SR 92 Improvements from US 41/SR 3/Cobb Parkway to Glade Road

Project Numbers: CSSTP-0006-00(862) and BRST0-0213-01(005)

Value Engineering Study Report Design Development Stage

March 2009

ALTERNATIVE B-6
SHEET 2 of 8
ORIGINAL DESIGN

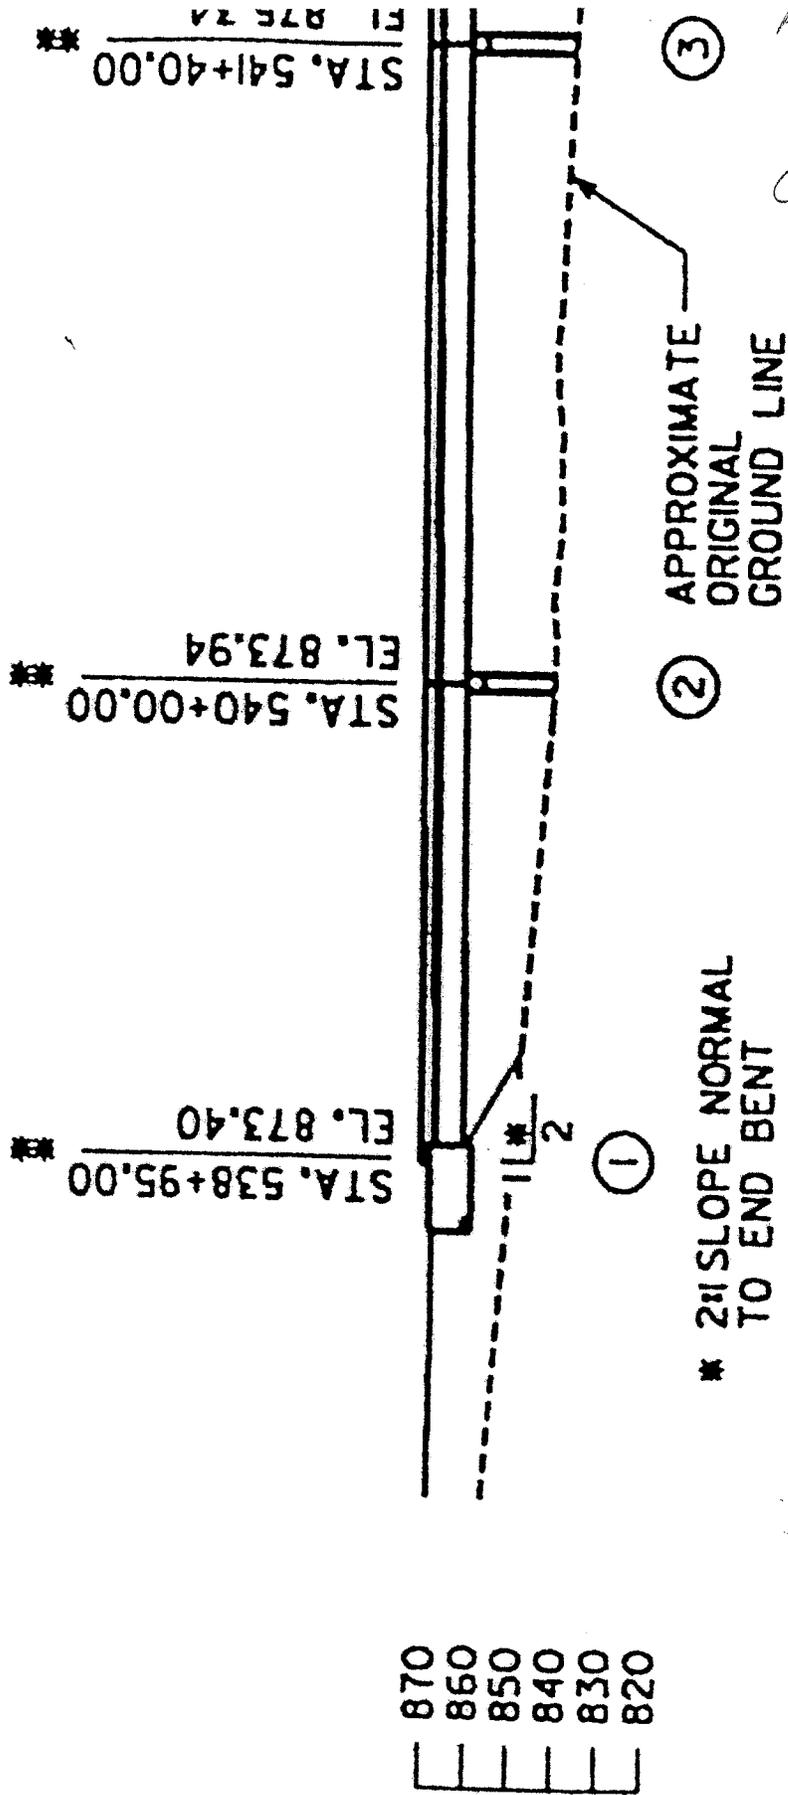
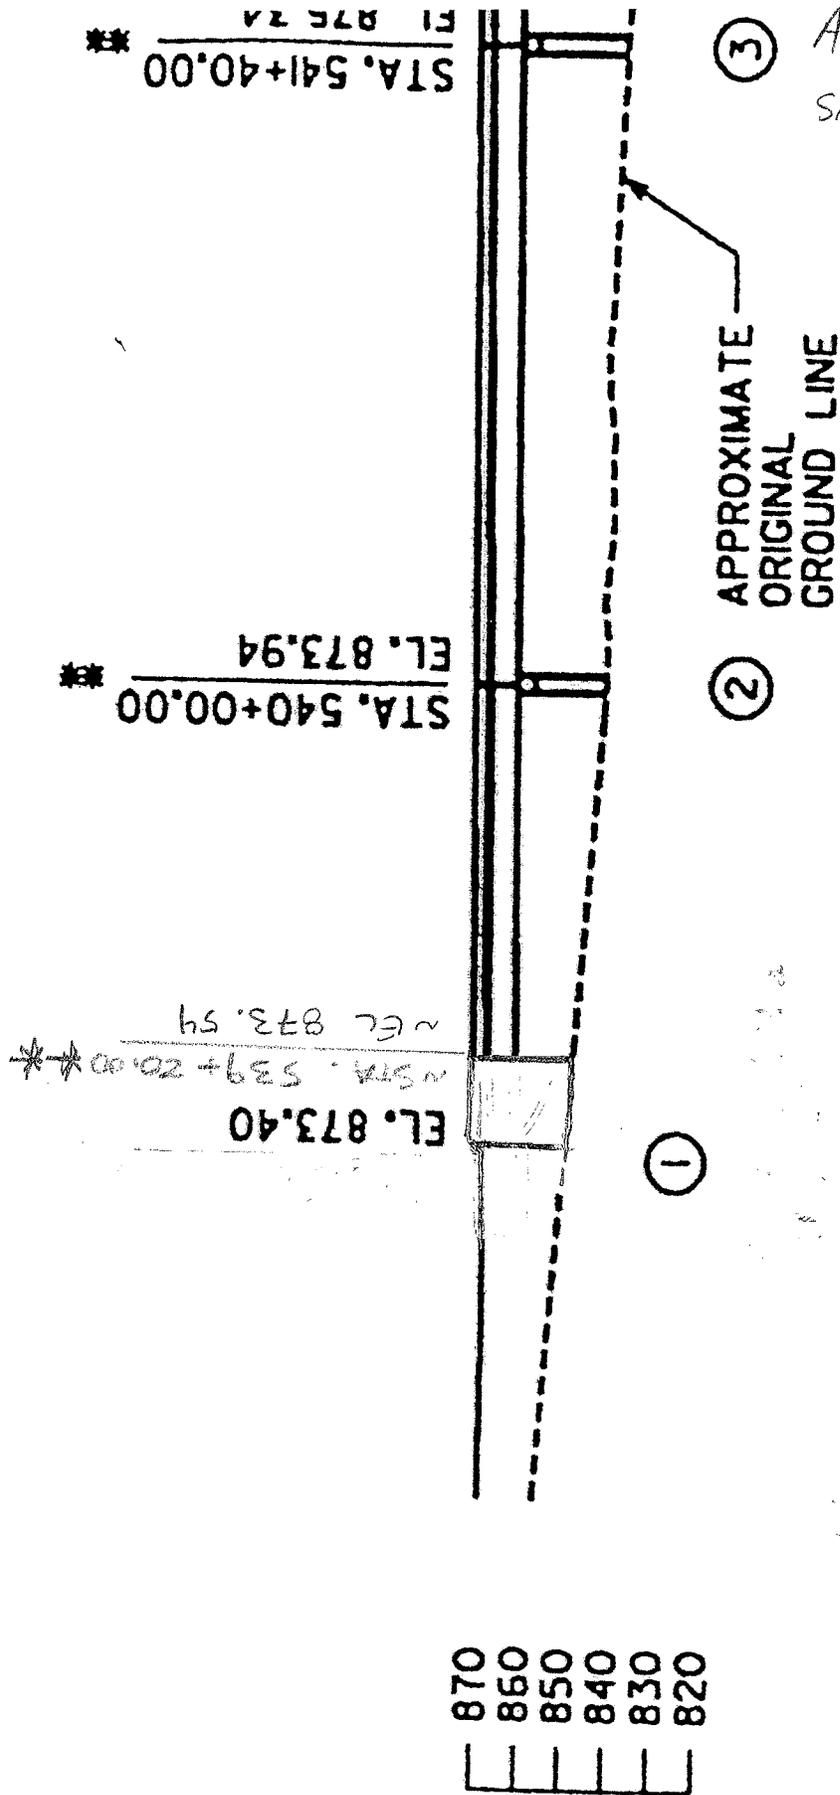
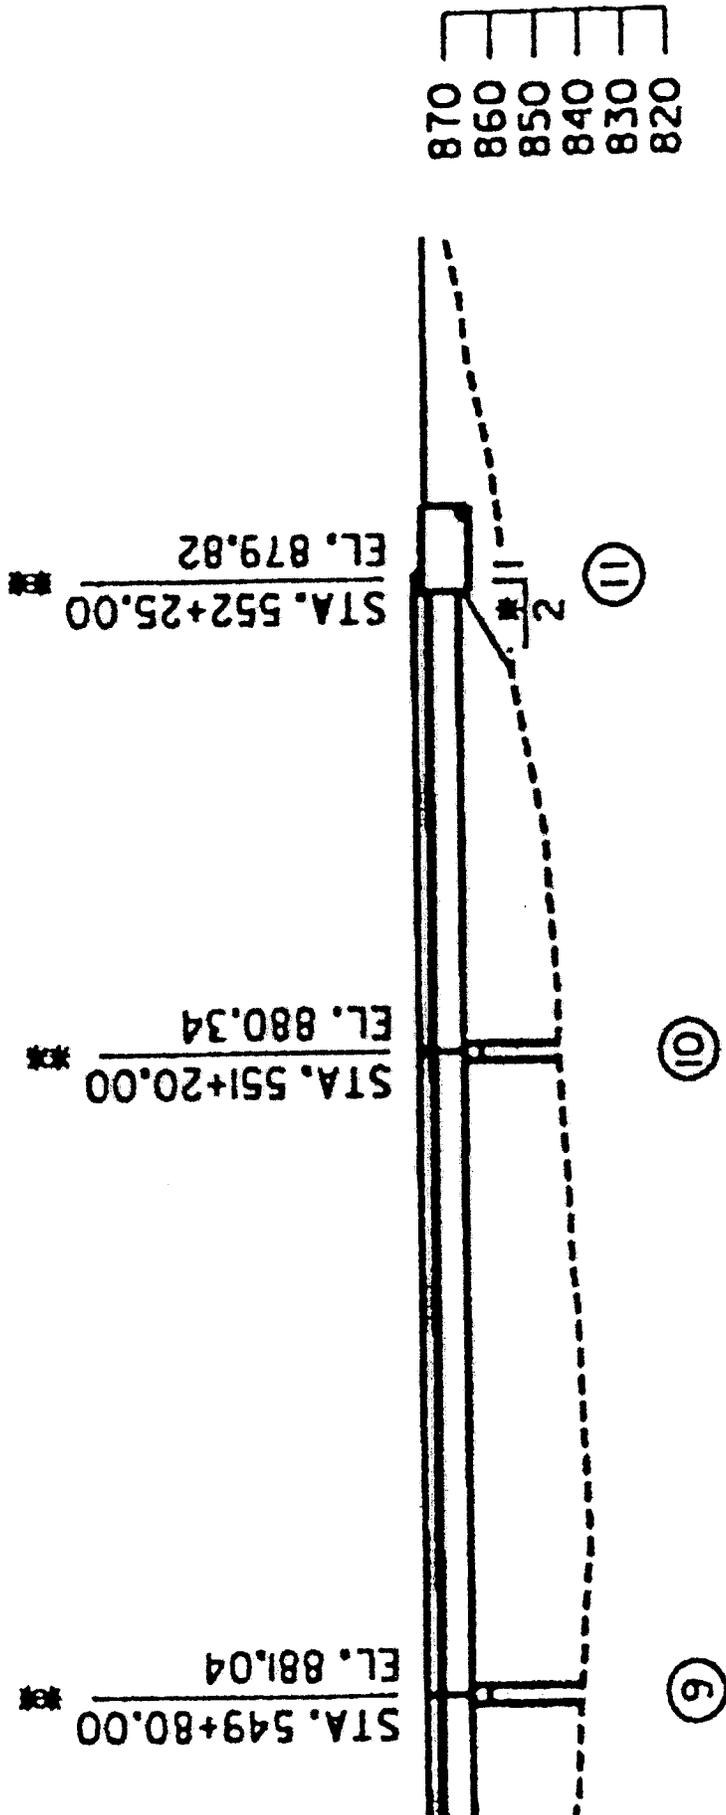
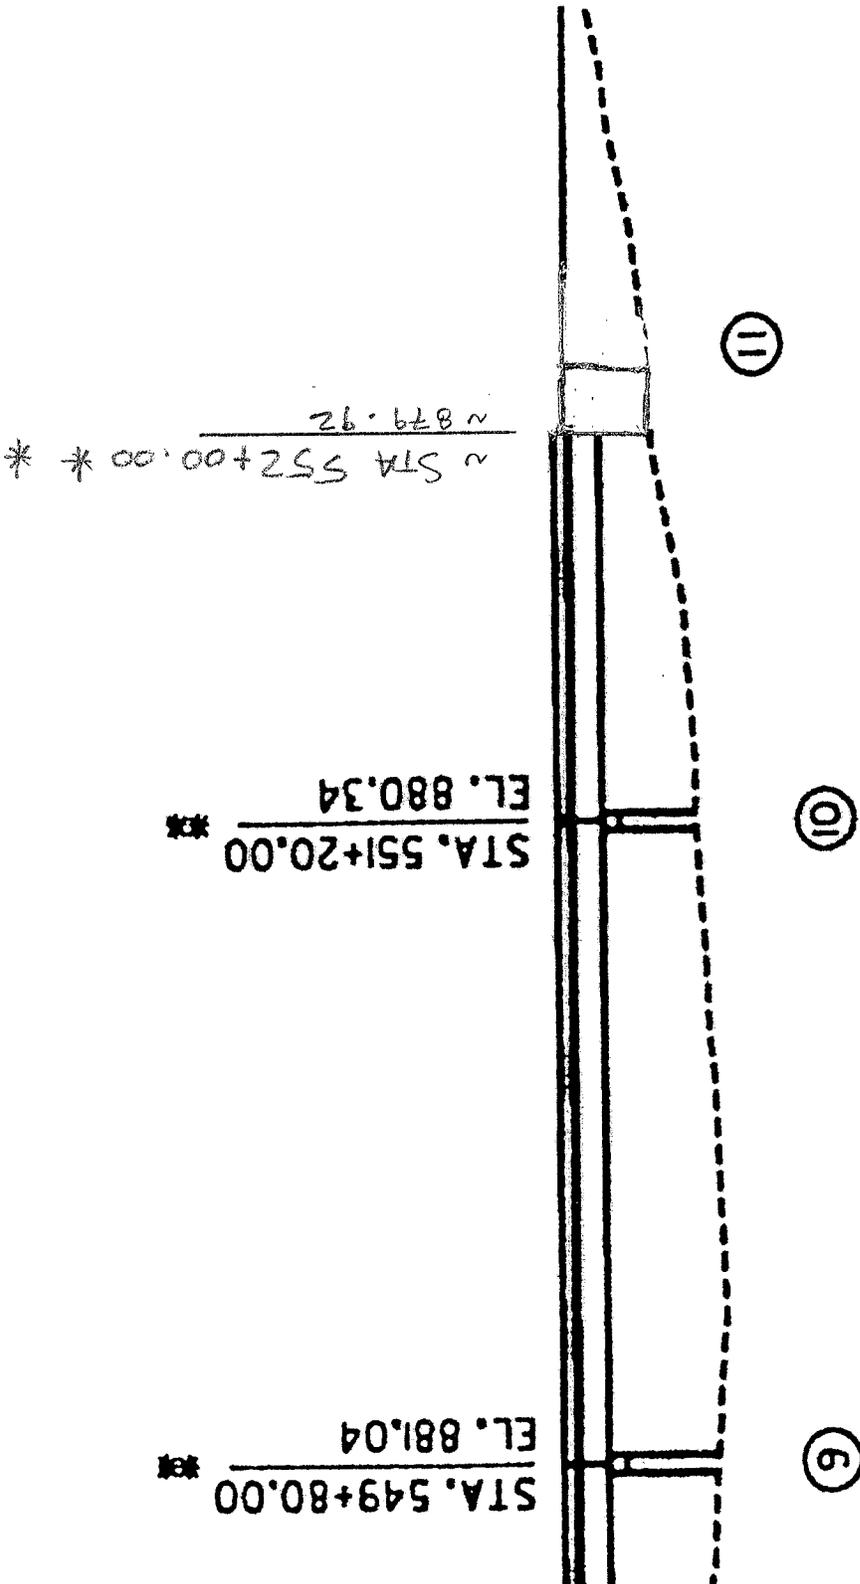
DESCRIPTION: **INCREASE ABUTMENT AND WING WALL HEIGHT TO** SHEET NO.: **1 of 8**
REDUCE THE LENGTH OF THE 1,330-FT BRIDGE

Vertical abutments are acceptable in locations where future expansion is not anticipated.

Alternative W-4

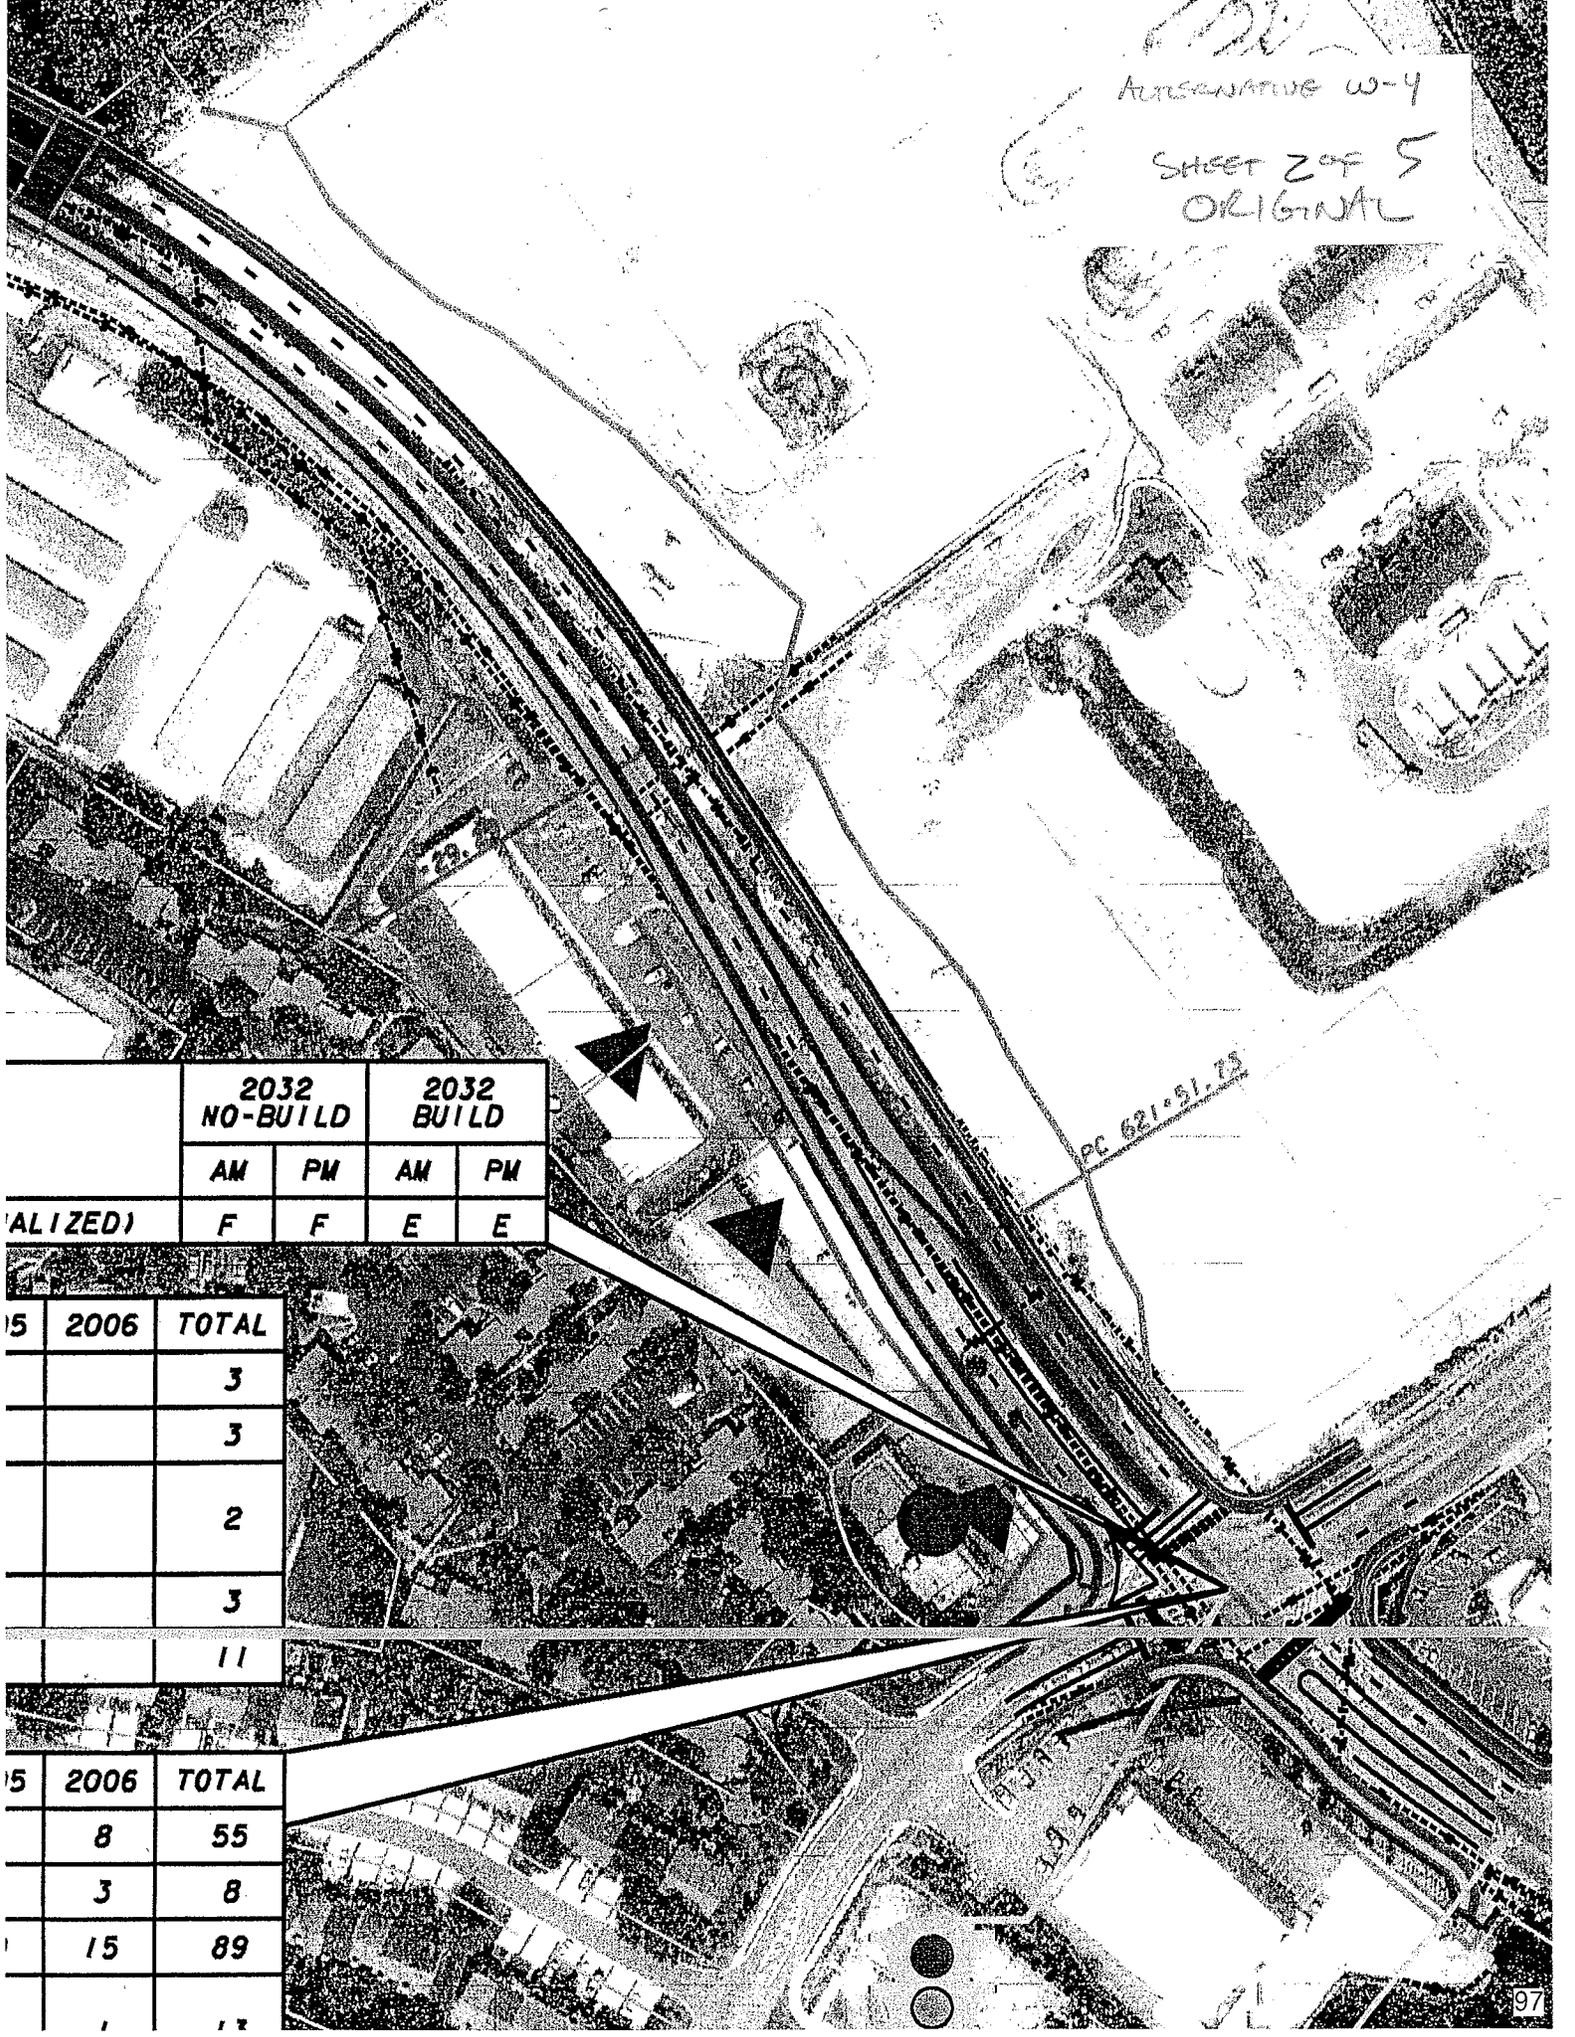
DESCRIPTION: **USE AN MSE WALL FROM (LT) STA 612+00 TO STA 623+00** SHEET NO.: **1 of 5**
TO REDUCE COMMERCIAL RIGHT-OF-WAY
REQUIREMENTS
